Office Action Summary	Application No. 10/525,030	Applicant(s) ATREY ET AL.	
	Examiner DNYANESH KASTURE	Art Unit 3746

DETAILED ACTION

Figure 4 of Morse et al

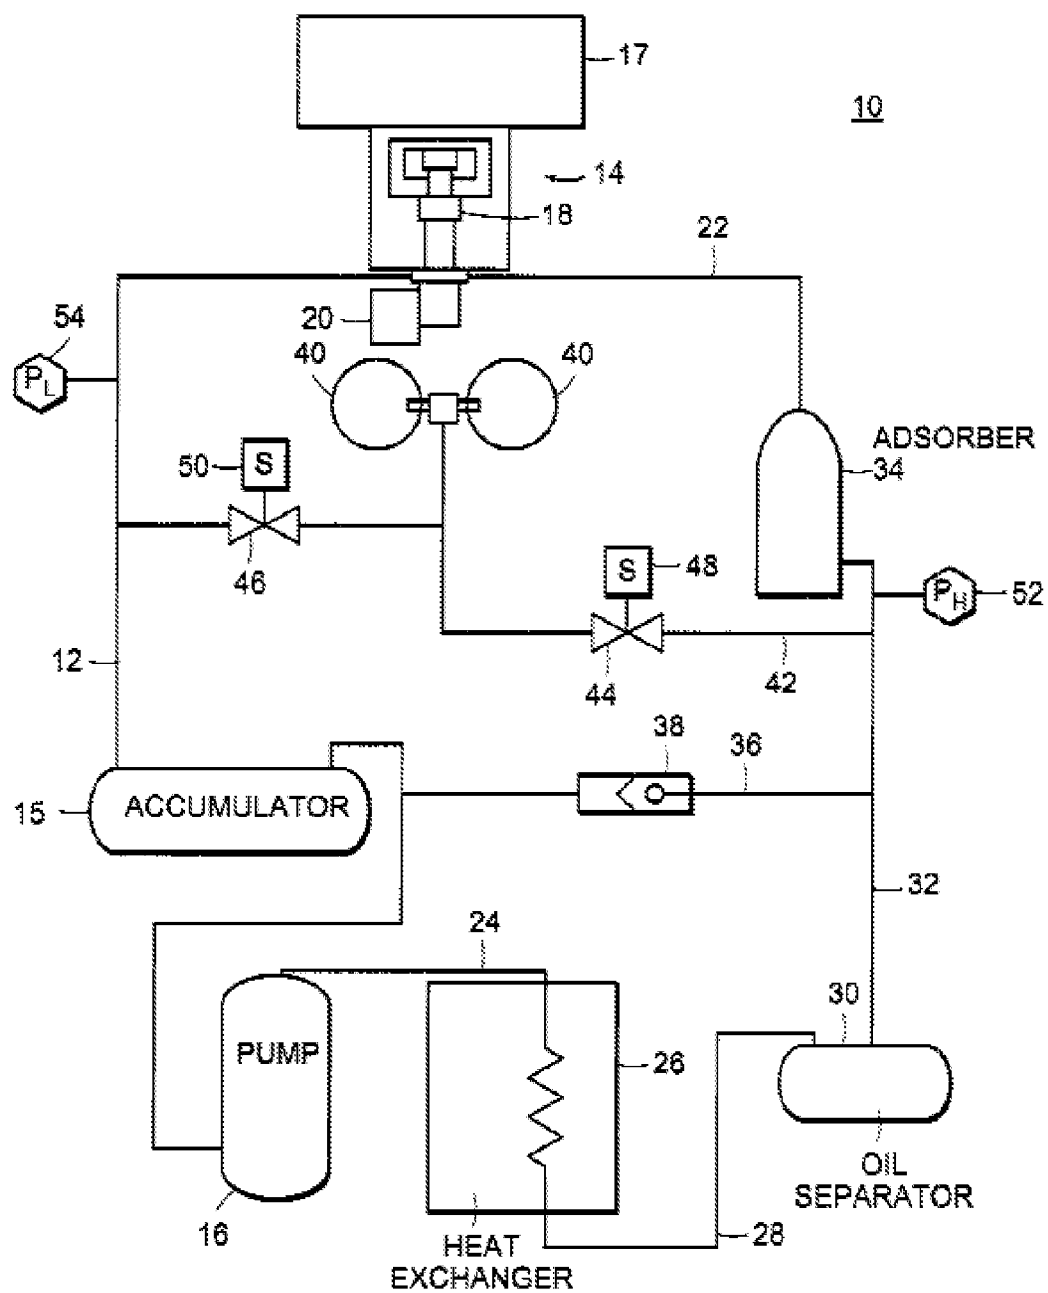
5. In Re claim 1, with reference to Figure 4 above, Morse et al discloses a pumped helium circuit (column 3, lines 25-29) comprising:

- a compressor (16)
- high pressure port which is inherent to the compressor pump outlet
- low pressure port which is inherent to the compressor pump inlet

- supplied equipment (17)
- compressed helium is supplied through line (22) and returns from line (12)
- a pressure relief valve (38) which opens in response to a predetermined pressure differential linking the high and low pressure ports as stated in column 3, lines 55-60: "When the pressure of the helium within the supply line 32 reaches a certain point beyond the pressure necessary to overcome the bias against the valve, the valve opens to allow helium to flow from the helium supply line to the helium return line 12.."

- With regards to "means for preventing oil carry-over from the compressor to the supplied equipment, characterized in that said means comprises means for preventing oil leaving the low pressure port and traveling towards the supplied equipment" within claim 1, this limitation meets the three prong test per MPEP 2181 and thereby invokes 35 USC 112 6th paragraph. The means for preventing oil carry-over from the compressor to the supplied equipment has been disclosed in the specification as a gas reservoir, oil trap or an oil adsorber which prevents oil from leaving the low pressure port and travels towards the supplied equipment. Morse et al discloses an accumulator (15) which provides a "Buffer" as stated in column 3, line 31, and positioned between the supplied equipment and the compressor. In addition, Petty discloses evidence in

Column 1, Lines 13 – 18 that an accumulator typically interposed between an evaporator (supplied equipment) and compressor can function as an oil trap. Also, as applicants suggest in their response to the first office action, the buffer of Morse et al smooths variations in pressure and in order to perform the smoothing function the accumulator needs to be a gas reservoir. The accumulator (15) of Morse et al is therefore is an equivalent element for at least an oil trap or gas reservoir.

6. However, Morse et al does not disclose a non-return valve located between a low pressure side of the pressure relief valve and the supplied equipment.

Figure 5 of Tanaka et al

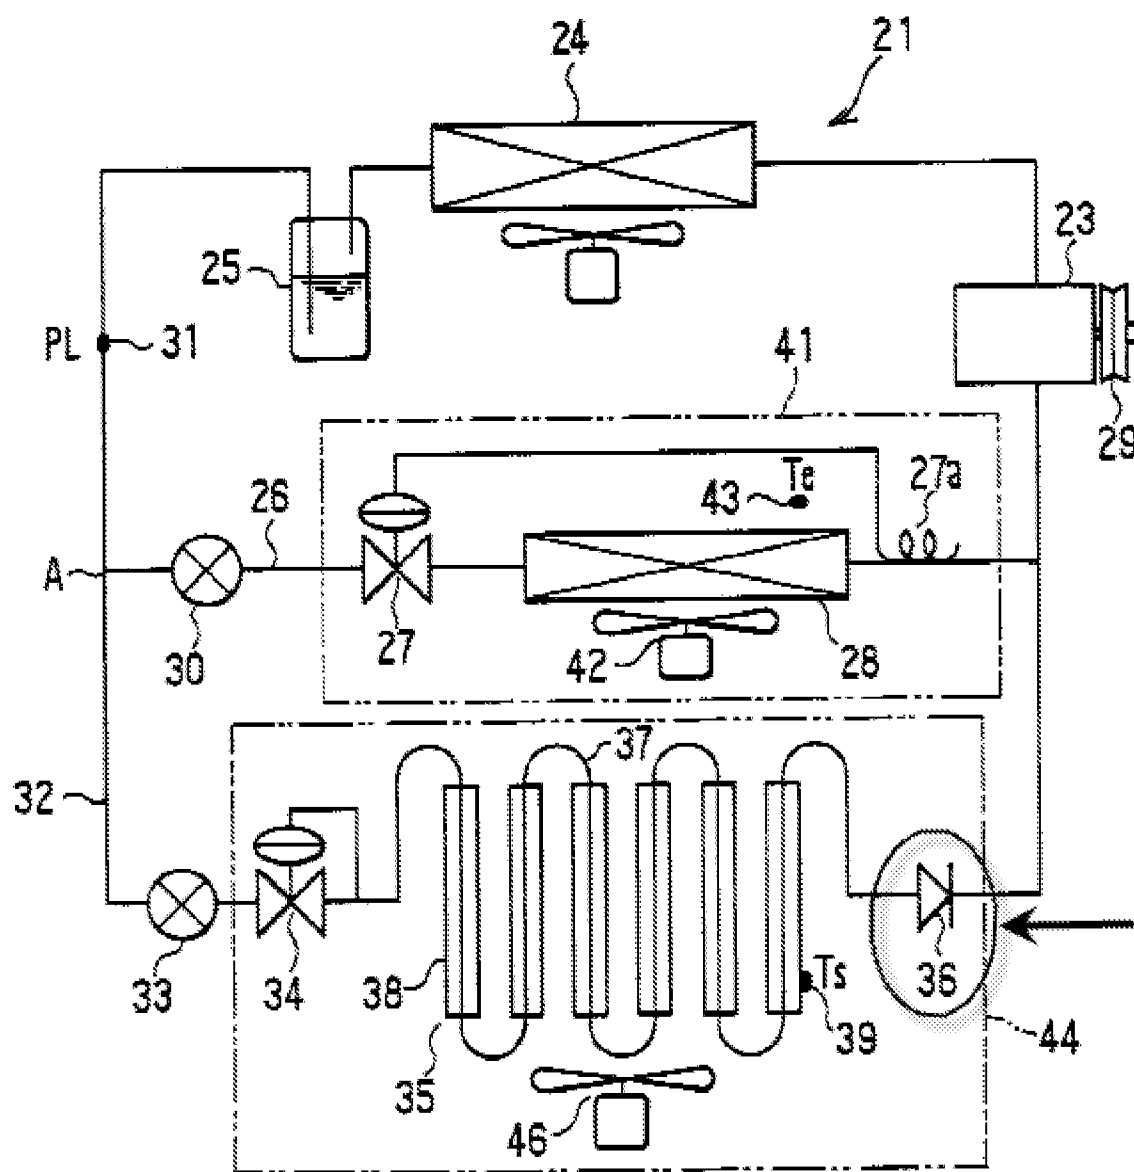
7. Nevertheless, Figure 5 of Tanaka et al discloses a vehicle air conditioning apparatus comprising a Check Valve (36), a non return valve disposed close the supplied equipment (evaporator) in a refrigeration circuit.

8. It would have been obvious to a person having ordinary skill in the art at the time of the invention to modify the pumped helium circuit of Morse et al to incorporate the check valve of Tanaka et al in the helium circuit between a low pressure side of the pressure relief valve and the supplied equipment for the purpose of ensuring one way flow of refrigerant.
